AMENDMENT 1 AMENDEMENT 1

Electric motor-operated hand-held tools, transportable tools and lawn and garden machinery –

Part 2-1: Particular requirements for hand-held drills and impact drills

Amendment 1 to IEC 62841-2-1:2017 has been prepared by IEC technical committee 116: Safety of motor-operated electric tools.

Figure 105 – Reaction torque measurement of single handle tools (2)

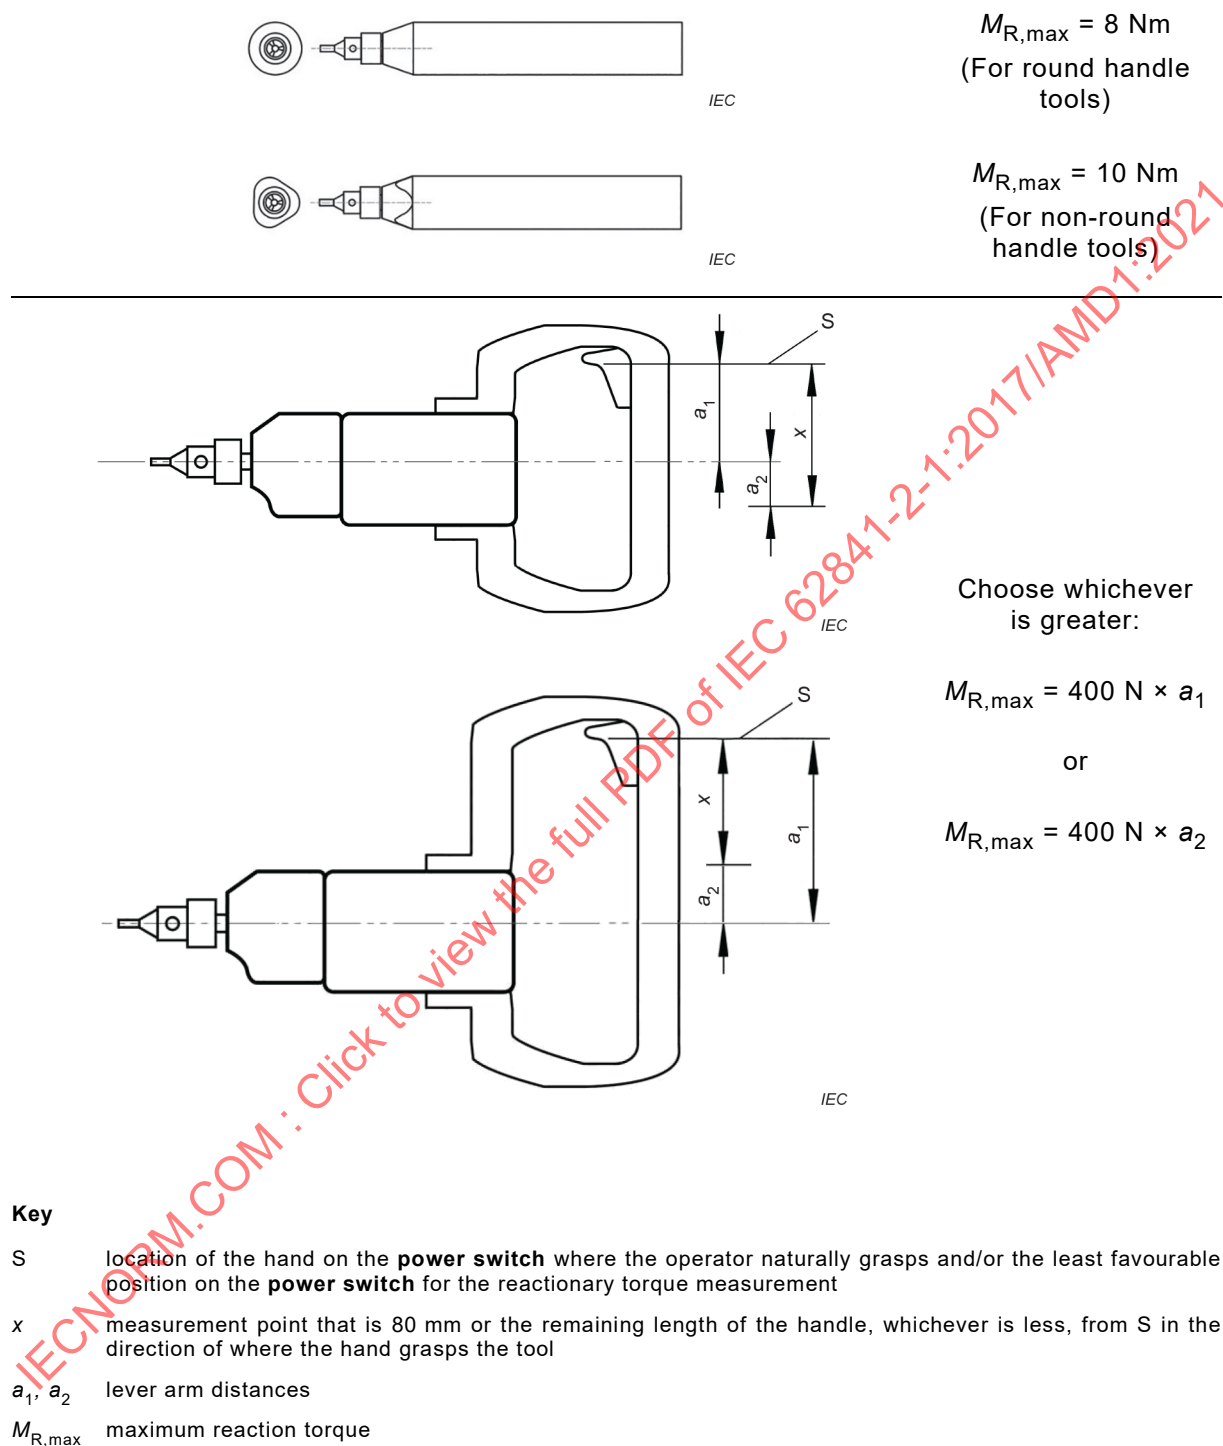
Replace the existing Figure 105 with the following new figure:

Figure 105 – Mesurage de couple de réaction des outils équipés d'une seule poignée (2)

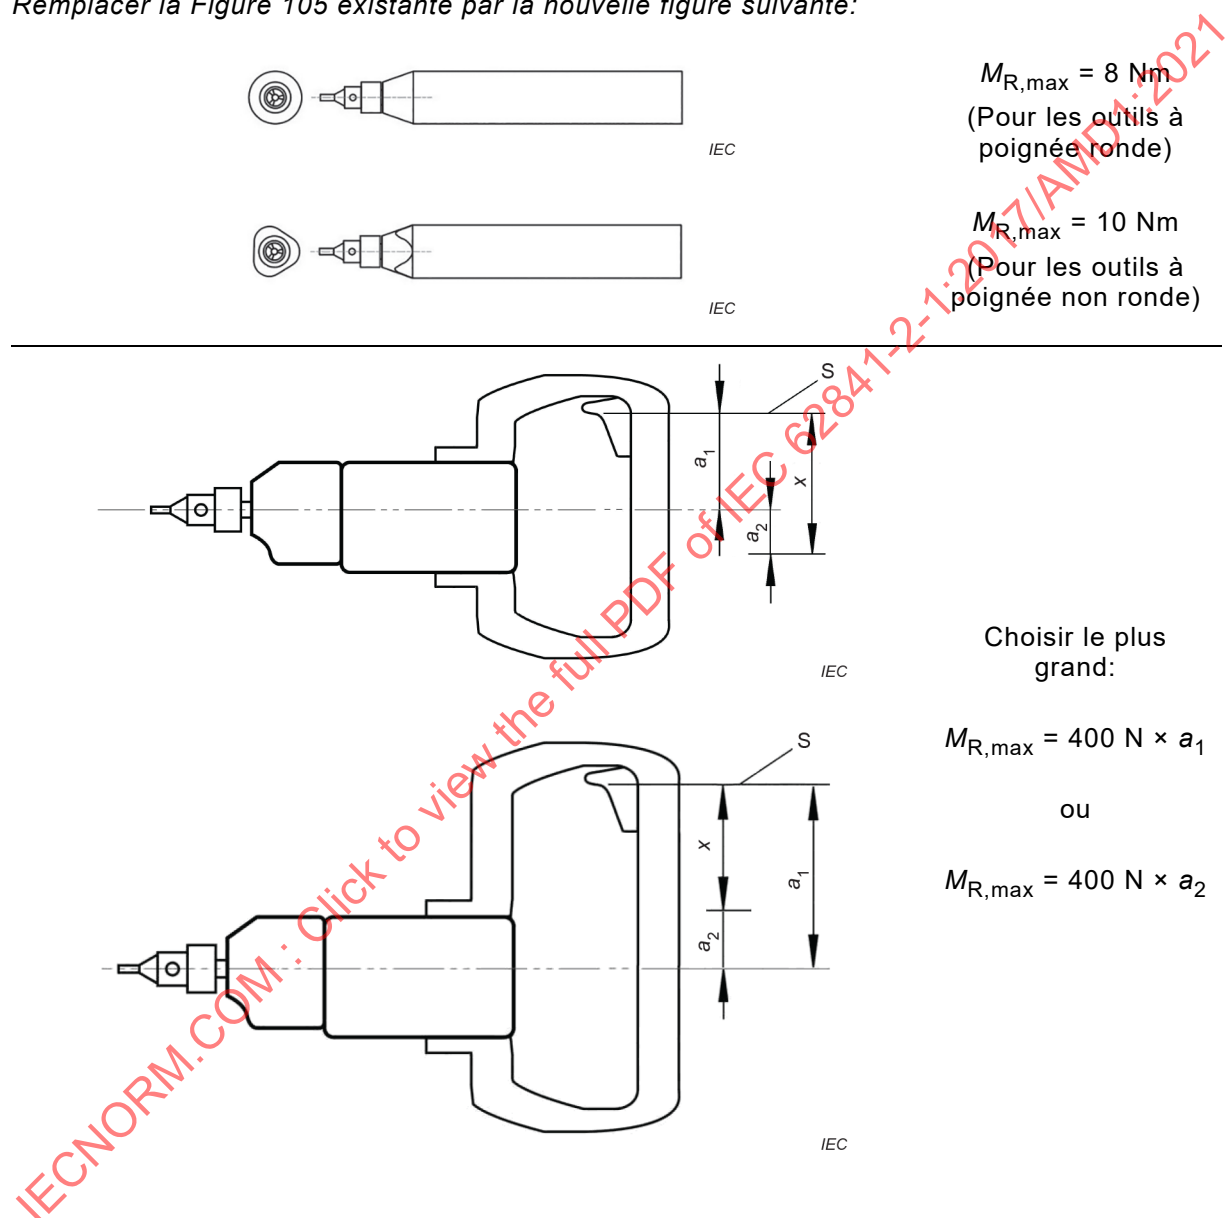
Remplacer la Figure 105 existante par la nouvelle figure suivante:
